Consider/Approve CO #29-20

FLOYD CENTRAL HIGH SCHOOL CHANGE ORDER REVIEW

Work Changes Proposal Request

REVISED ATHLETIC BUILDING BATHROOM LIGHTING

AE1.1-PR2

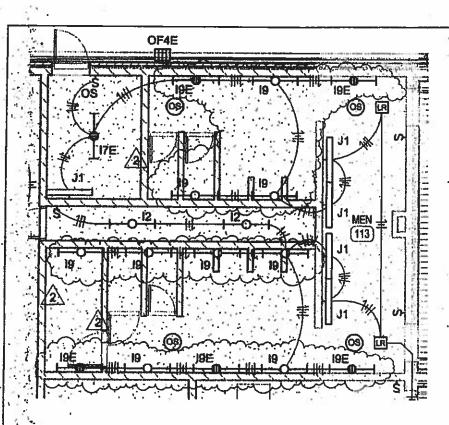
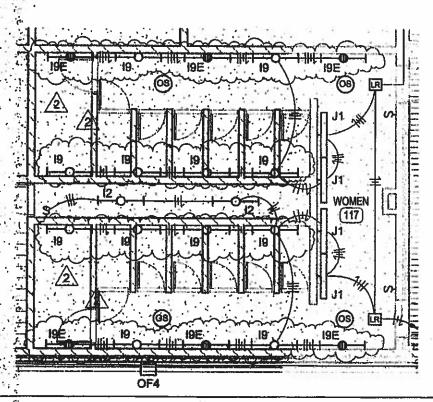
PROVIDE PRICING TO REPLACE H1/H1E, H2, AND H4 FIXTURES IN MEN 113 AND WOMEN 117 WITH 19/19E FIXTURES AS SHOWN.

19 FIXTURE SHALL BE CORNER MOUNT LUMINAIRE-LED CLF74-25W-4000K-120-277-OP-WHT-DAMP-COR

19E FIXTURE SHALL BE CORNER MOUNT LUMINAIRE-LED CLF74-25W-4000K-120-277-OP-WHT-DAMP-COR-EMB310
